Ardgour Rise Road Safety Review

Alternate Alignment Safety Review

Prepared for:
Santana Minerals Ltd

Project/File:
310206156

Figure 10: Example of revised design

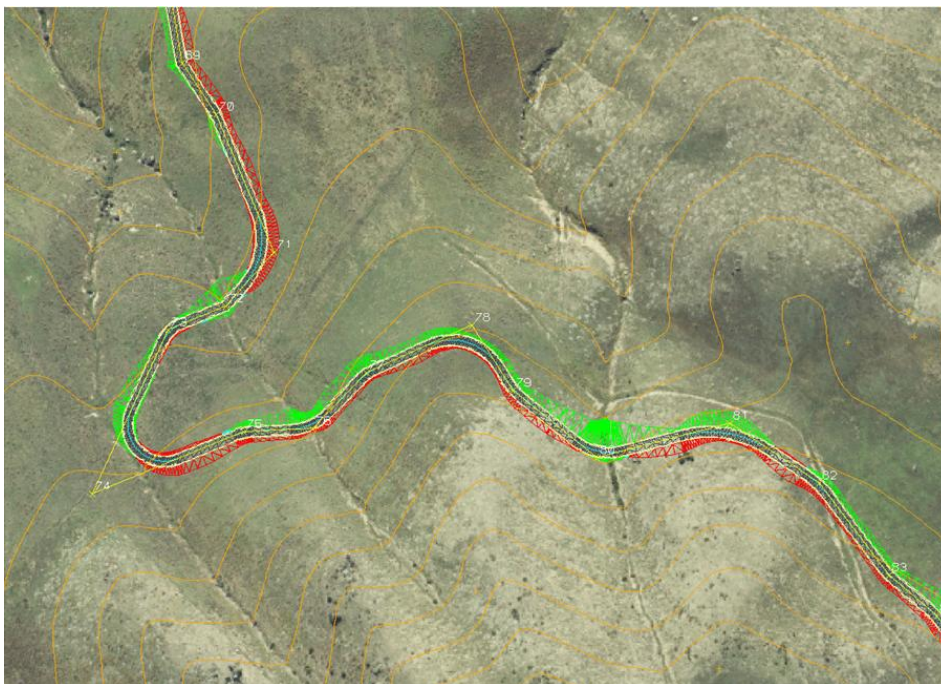
A revised design was submitted on Monday 27th July 2026, with further discussions with the designer that same day. This revised design revealed an alignment from CH 4880 to CH 5440 with a gradient on average of below 12.5%. This was achieved through traversing further into gullies, and a general shift utilising a longer distance for the grade change. It is considered that this style of change is demonstration that a redesign of the alignment further in detailed design would result in a more suitable gradient.

A modified design has been undertaken that results in the general elimination of grades above 13%, from CH 3960 through to above CH 8580. This is discussed further in Section 3.3 below.

Figure 11: Alignment height / Grade comparison graph.

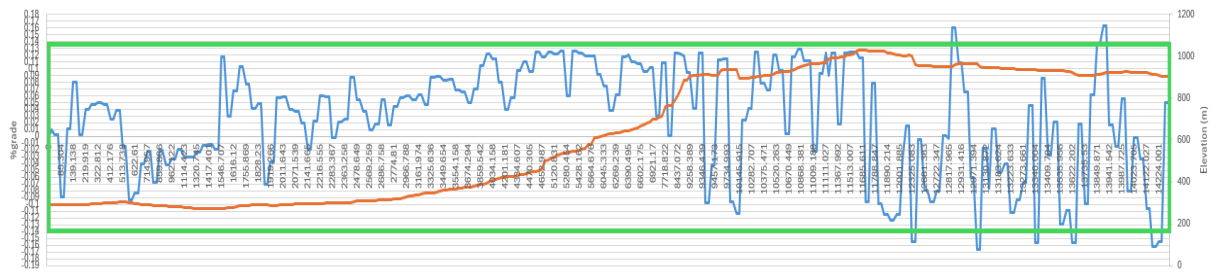
Figure 11 below details the new road profile (orange), with gradient (blue). The boundary box (green) is the bounds of 12.5% gradient. As demonstrated, there remains isolated sections of road above 12.5%, being the alignment along the highest portion of the proposed road.

Figure 12 demonstrates areas where the Revision 4 design steep grade sections (green) have been reduced, resulting in a less steep alignment in Revision 5 (orange). It is acknowledged that there are short sections of steep grade (16%) along the tops, however these are isolated in length, with recovery grades between.

Figure 13: Grade Summary Analysis

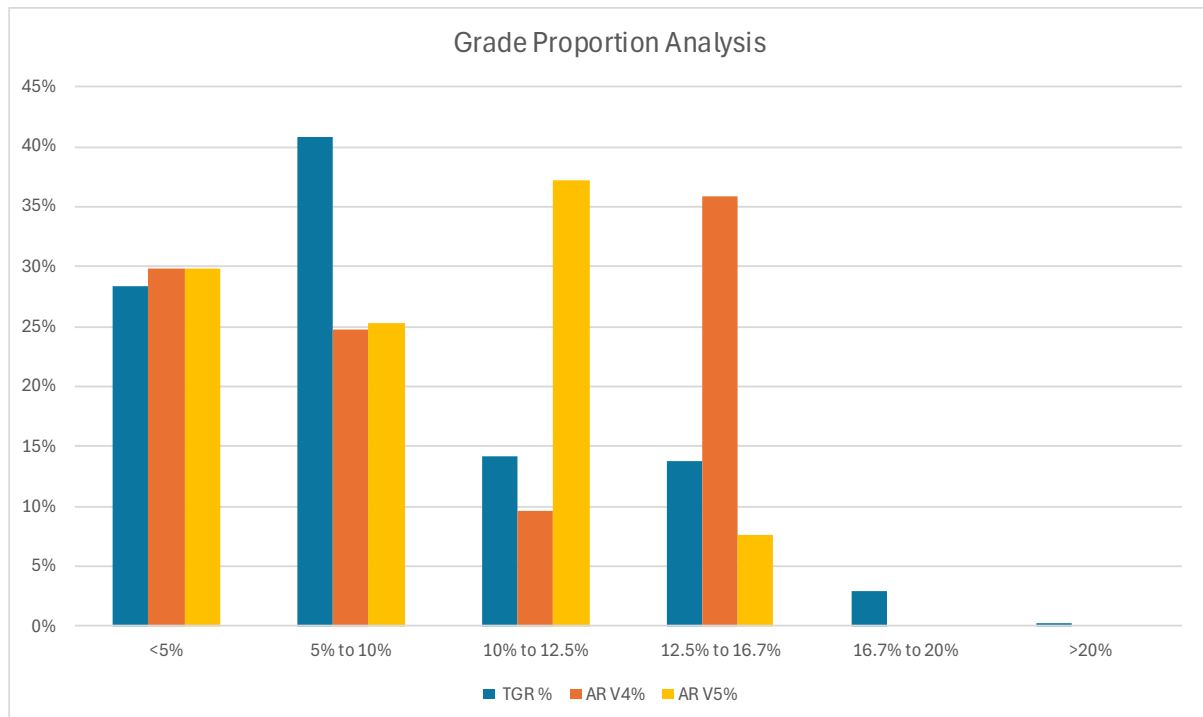
The length of both the Ardgour Rise V4 and V5 designs is 13.6 km and 14.3 km respectively. Analysis of the grade data has been undertaken from a start point at the entrance to the mine site, commencing at Thomson Gorge Road, and traversing through to rejoining Thomson Gorge Road at CH 12.1 km.

An analysis of the V4 design as submitted to the hearing had a higher proportion of grades in the 12.5% to 16.7%. The version 5 design has reduced this.

This analysis reveals that the Ardgour Rise alignment (V5) results in a lower percentage of length at the higher grades, with no grades exceeding 16.7%. This is achieved through utilising a higher proportion of mid-range grades (10 to 12.5%).

In summary, the Ardgour Rise V5 alignment generally results in a reduction of steeper grades when compared to the existing Thomson Gorge Road alignment, and is generally compliant with the ARRB guidelines.
